• 4.9 JUNCTIONS IN DRAINS

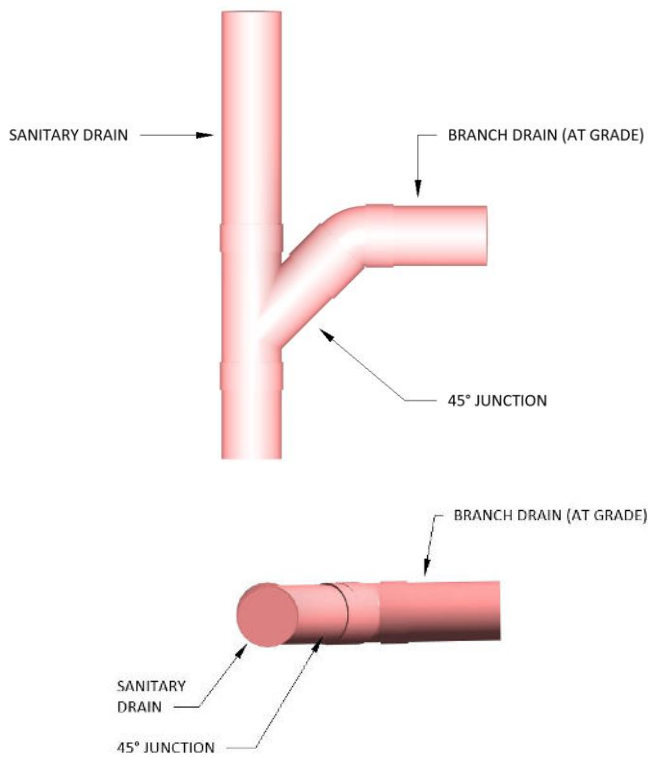
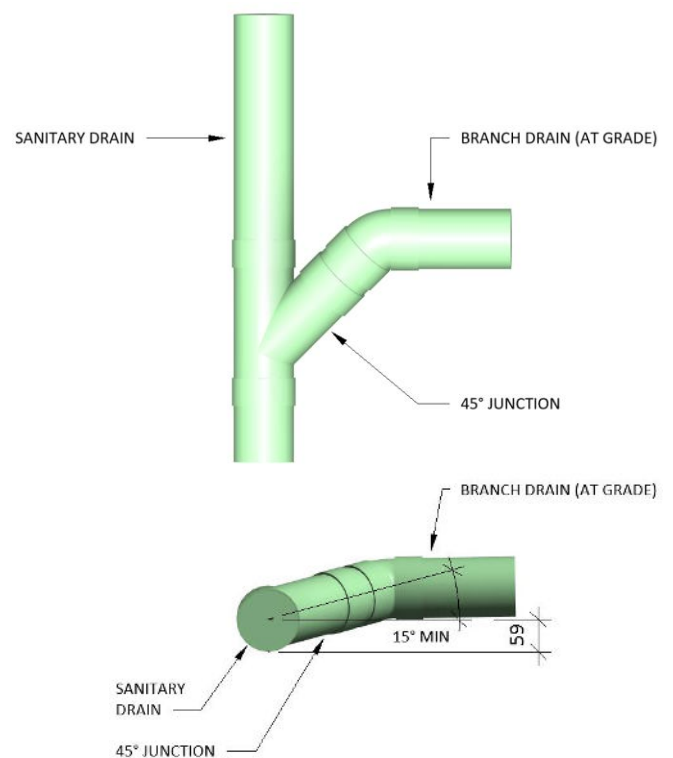
Before the adoption of AS/NZS 3500.2:2021, where a 45° junction was to be used to connect a branch drain to a main drain of the same size, the entry level of the branch drain could be installed at grade.

After the adoption of AS/NZS 3500.2:2021, where a 45° junction is to be used to make the connection of a 100Ø drain to another 100Ø drain, the entry level of the branch drain shall be elevated at an incline of not less than 15° above the horizontal

Property sewer connection depths need to be reviewed at the early stages of the project.

Consideration of ceiling space is a must during the design phase.
